Re: **COVID 19 Reopening Guidance – Facilities Clarifications**

**Office of Facilities Planning, New York State Education Department August 17, 2020
COVID-19 Reopening Guidance – Facilities Issues Clarifications**

4. **FAQ No.11 (Revised)**

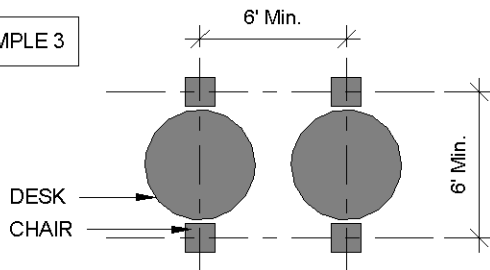
Where do we take measurements from to establish social distancing; for example in the layout of furniture/equipment/etc.?

To achieve acceptable social distancing between the occupants of classroom desks, chairs and teaching consoles, establish a minimum of 6' separation measured to the centerline of individual's space. Measurements should be taken in a manner consistent with the example diagrams below.
